Item Name: Crosstube Turning Detail

DART AEROSPACE LTD		Work Order:	85829
Description: Crosstube Assembly (205/212/412 High Fwd)		Part Number:	D212-664-141
Inspection Dwg: D212-664-141 Rev: D		Page 1 of 2

DRAWING NO. D212-664-141	TITLE XTUBE ASSY (205/212/412 HI FWD)	REV. D	DART AEROSPACE LTD ENGINEERING ORDER		D.E.O. NO. D212-664-141-D-1	SHEET NO. SHEET 1 OF 2	SCALE NTS
DRAWN	CHECKED	MFG. APPR.	APPROVED	DE APPR.			
DATE 11.04.07	DATE 11.07.11	DATE 11.04.12	DATE 11/04/12	DATE 11.04.12

DRAWING NO. D212-664-141	TITLE CROSSTUBE ASS'Y (205 HI FWD)	REV. D	DART AEROSPACE LTD ENGINEERING ORDER		D.E.O. NO. D212-664-141-D-2	SHEET NO. SHEET 1 OF 1	SCALE NTS
DRAWN <i>UP</i>	CHECKED <i>ASS</i>	MFG. APPR. <i>AB</i>	APPROVED <i>MD</i>		DE APPR. <i>CH</i>		
DATE 11.07.15	DATE 11.07.20	DATE 11.07.21	DATE 11/07/21		DATE 11.07.21

**D212-664-141/-141B
ASSEMBLY DETAIL**

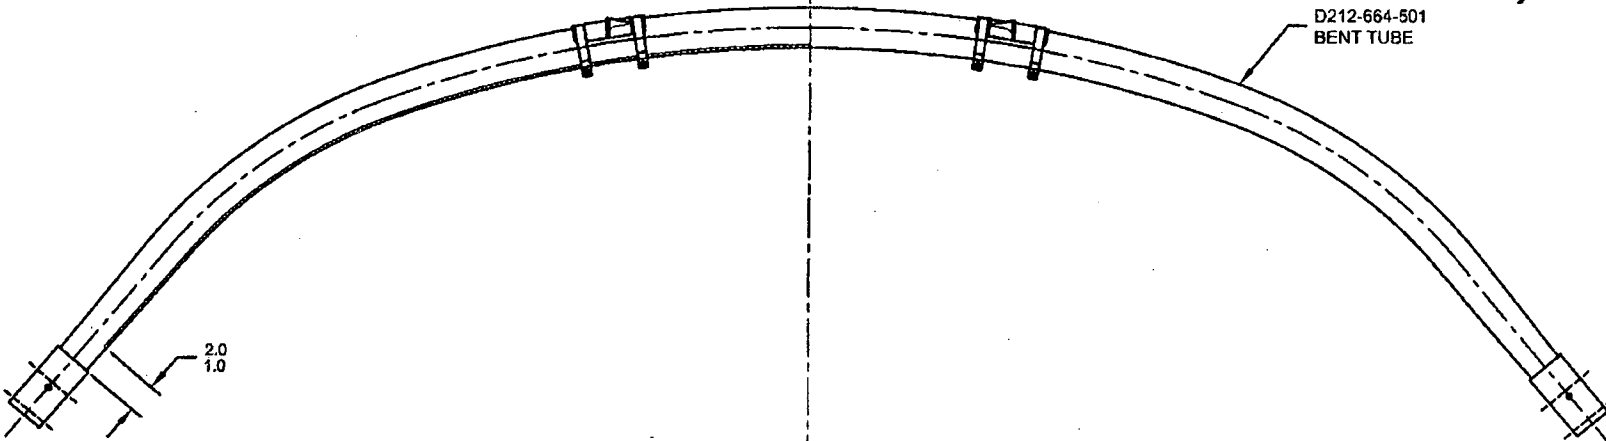
PURPOSE:

ADD AN INSPECTION WINDOW TO UNDERSIDE OF CROSSTUBE.

MASK AREA PRIOR TO PAINTING,
REMOVE MASKING AFTER PAINT
AND APPLY CLEAR COAT

IS:

WAS:
